## **PLAN REVIEW SHEET**

**Telephone:** 704-353-0018 **Petition:** 2018-015

NVR Inc. Email: bhorton@charlottenc.gov
Attachments: Bus stop pad detail

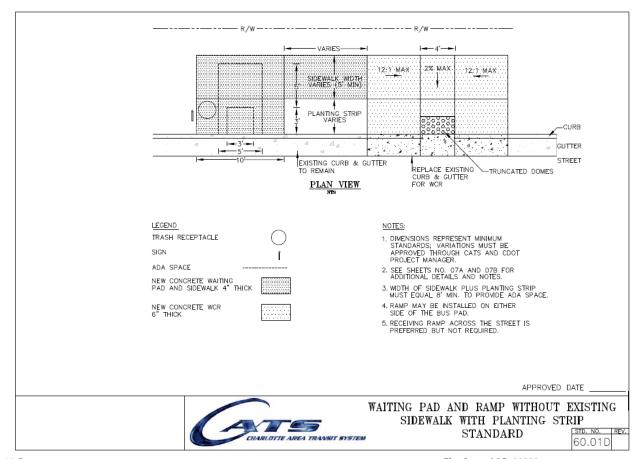
The Petitioner is requested to provide and construct a new waiting pad for a new bus stop pair (or two stops) on Cindy Lane. The westbound stop should be located along the site's frontage, where not conflicting with a right-turn lane. The eastbound stop should be within the right-of-way, where curb ramps to cross Cindy Lane can be aligned to access the eastbound stop.

Below is an image of the standard detail (60.01D) for each of the two requested bus stop pads. Note the distance between the westbound bus stop pad and the sidewalk curb ramp may be significant, as needed to align the ramp opposite the ramp immediately across from the eastbound stop. The eastbound stop can have minimal to no sidewalk between the ramp and bus stop, as well as no planting strip, to minimize construction across from the development site.

The location of the curb ramps and resulting crossing needs to be coordinated with Charlotte Department of Transportation Permanent easement is requested for the westbound stop, where dimensions exceed existing or proposed right-of-way limits. The eastbound stop design falls within existing right-of-way.
